# Recall Bulletin

## F/CMVSS NONCOMPLIANCE RECALL

**SUBJECT:** Passenger Side Instrument Panel Performance

**MODELS:** 2009-2014 Chevrolet Express  
2009-2014 GMC Savana  
1500 Series Equipped with Passenger Side Airbag (AK5))

3804499

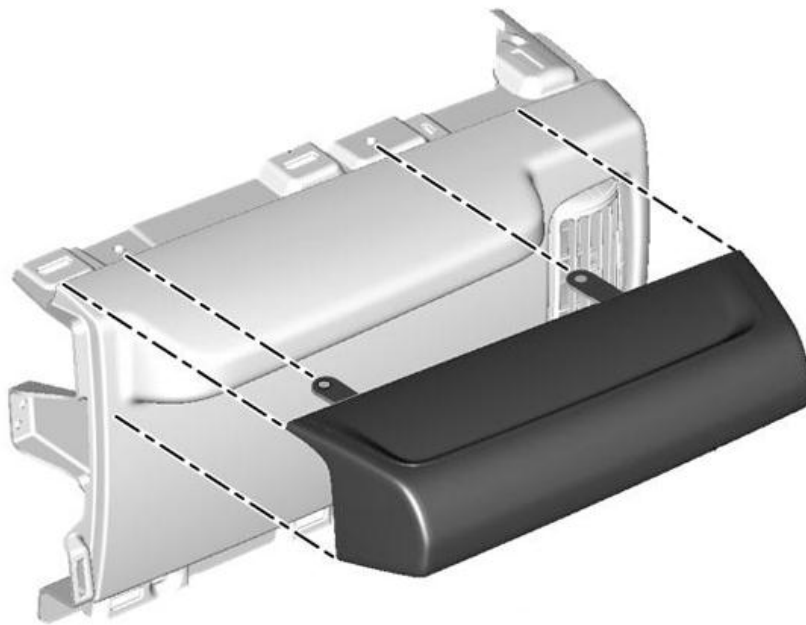
2. Remove the upper two screws that attach the instrument panel pad to the instrument panel bracket.

3. Inspect the brow assembly before installation to ensure the energy absorbing material is present.

3804499

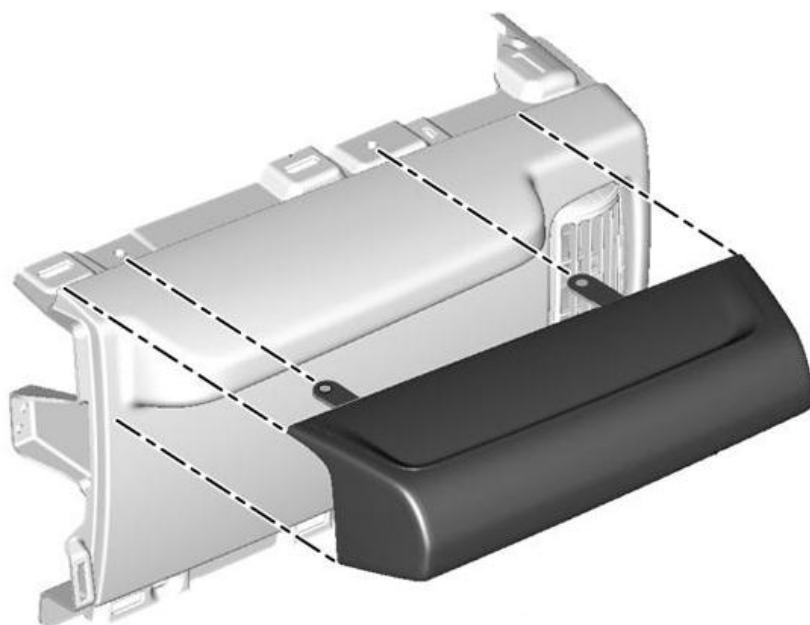
2. Remove the upper two screws that attach the instrument panel pad to the instrument panel bracket.

3. Inspect the brow assembly before installation to ensure the energy absorbing material is present.
